August 24, 2012
NRC3-12-0024

Subject: Detroit Edison Company Response to NRC Request for Additional Information Letter No. 78

Subject: Detroit Edison Company Response to NRC Request for Additional Information Letter No. 77

RAI Question No. 01.05-1

Figure 42: Comparison of the horizontal and vertical GMRS based on the Updated EPRI-SOG model with full CAV with the GMRS based on the CEUS SSC model with modified CAV.

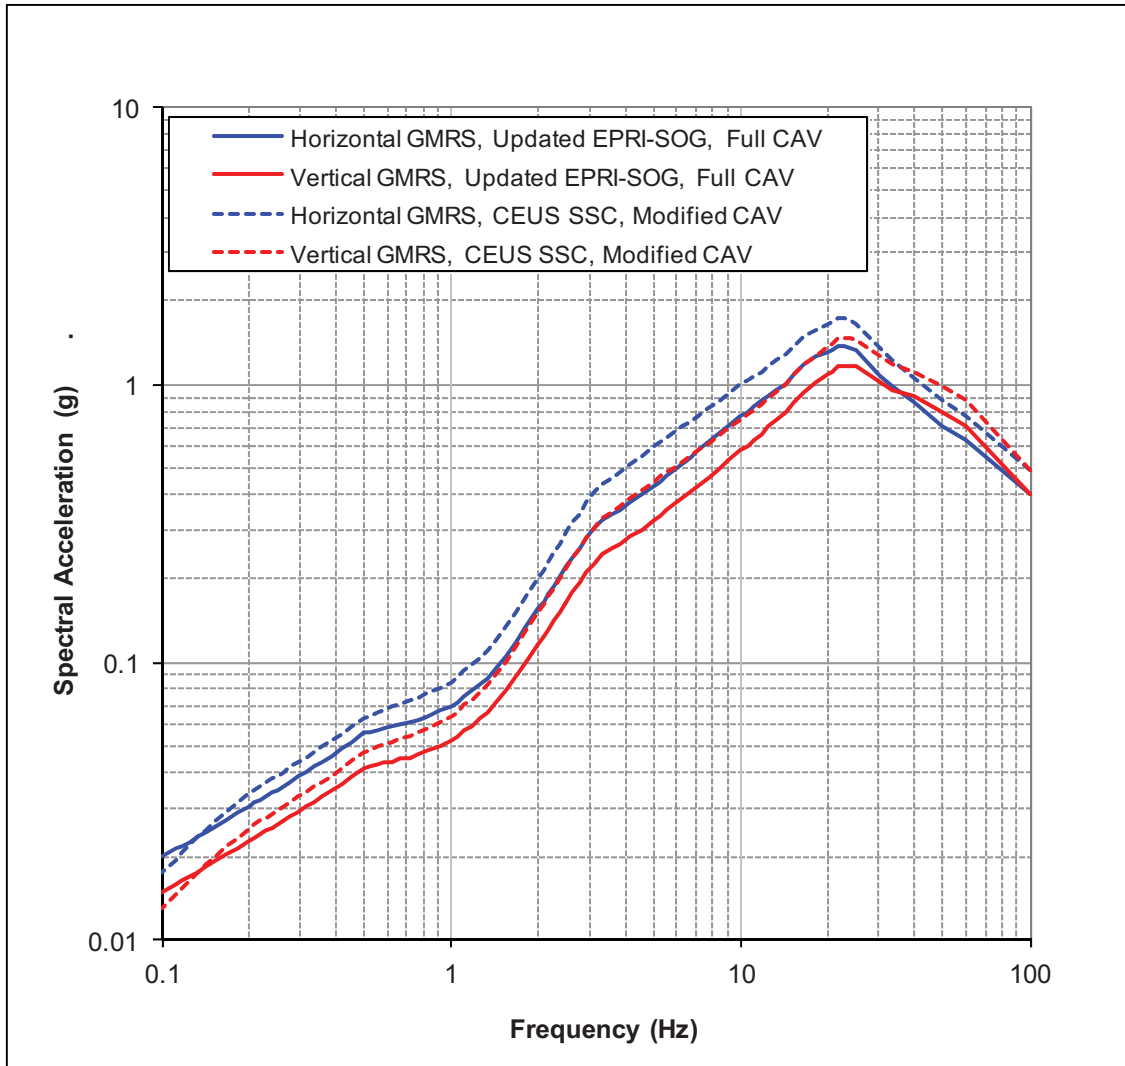
Table 5 lists the GMRS based on the CEUS SSC model and modified CAV application. The vertical GMRS is obtained from the horizontal GMRS using the vertical to horizontal spectral ratios presented in Fermi 3 FSAR Subsection 2.5.2.6. Figure 42 compares the GMRS based on the Updated EPRI-SOG model with full CAV to the GMRS based on the CEUS SSC model with modified CAV. The GMRS based on the CEUS SSC model and modified CAV is higher than the GMRS based on the EPRI-SOG model and full CAV at most frequencies. Near 0.1 Hz the GMRS based on the CEUS SSC model and modified CAV is about 12 percent lower than GMRS based on the EPRI-SOG model and full CAV due to the updated low frequency extension of the hard rock UHRS. The GMRS based on the CEUS SSC model and modified CAV compared to the GMRS based on the EPRI-SOG model and full CAV is summarized as follows:
